Report: TAB REPORT
Function: Test, Adjust, & Balance
Date: 02/24/2023

**02-20-23 CHICK-FIL-A #05047 -
SEVIERVILLE, TN (HWY 66 FSU) NEW
STORE**

Project: 02-20-23 CHICK-FIL-A #05047 - SEVIERVILLE, TN (HWY 66 FSU) NEW STORE

DAMPER.jpeg

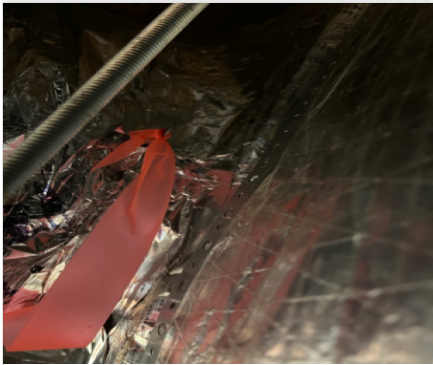
Issue Name : CRITICAL - AC1, AC2, AC3 / DAMPER TYPES

Description : AC1 - SGRD1,2,4,10,11,13 & EGRD5,6,9 DO NOT HAVE RUSKIN TYPE DAMPER HANDLES INSTALLED. AC2- EGRD2 & EGRD3 DO NOT HAVE RUSKIN TYPE DAMPER HANDLES INSTALLED. AC3- SGRD4 & SGRD5 DO NOT HAVE RUSKIN TYPE DAMPER HANDLES INSTALLED. RECOMMEND THE CORRECT TYPE DAMPER HANDLE TO BE INSTALLED.

AC3.jpeg

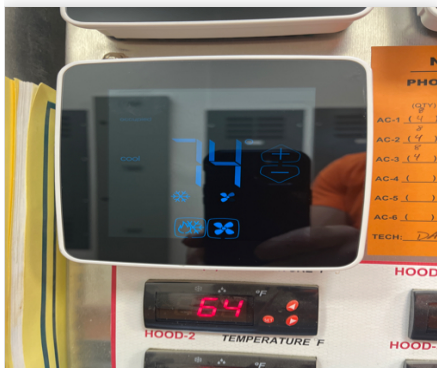
Issue Name : CRITICAL - AC3 / TEMP. SENSOR COMMUNICATION

Description : AC3 TEMP. SENSOR IS NOT COMMUNICATING WITH THERMOSTAT. RECOMMEND THIS ISSUE BE FIXED ASAP. PAGE: M-501 DETAIL: 2

TERMINALS.jpeg

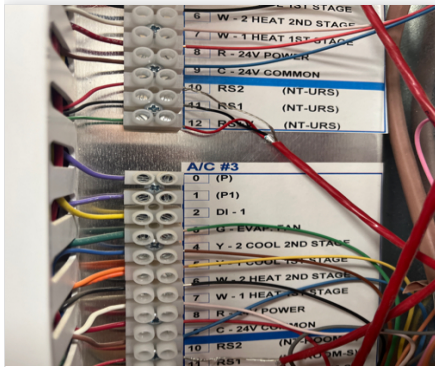
Issue Name : REVIEW + RECTIFY - AC1, AC2, AC3 / TERMINALS NOT WIRED

Description : AC1, AC2, AC3 TERMINALS P, P1, D1 ARE NOT WIRED. D1 WIRE NEEDS TO BE LANDED ON THE ESTOP TERMINAL IN EACH UNIT & TERMINAL WIRES FOR P & P1 NEED TO BE LANDED TO THE POTENTIOMETER MODULES IN EACH UNIT. RECOMMEND THESE TERMINALS BE WIRED AND LANDED TO THE CORRECT LOCATIONS ON EACH UNIT. PAGE: M-501
DETAIL: 2

EVAP.jpeg

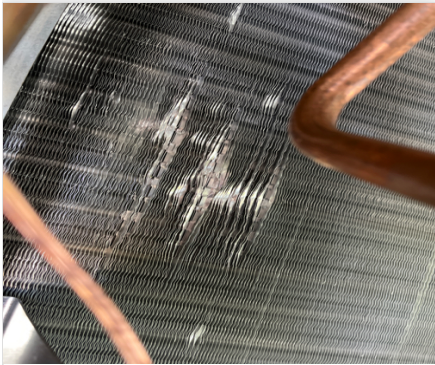
Issue Name : NON-CRITICAL - AC3 / EVAP COIL

Description : AC3 HAS SOME DAMAGE TO THE EVAP COIL. PAGE: M-901 NOTE: D

LAMINATED.jpeg

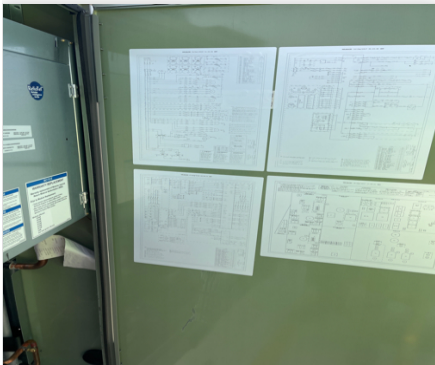
Issue Name : NON-CRITICAL - LAMINATED COPY OF WIRING DIAGRAM

Description : LAMINATED COPY OF WIRING DIAGRAM NEEDS TO BE PLACED IN THE ELECTRICAL CABINET OF EACH UNIT. PAGE: M-501 NOTE: 1
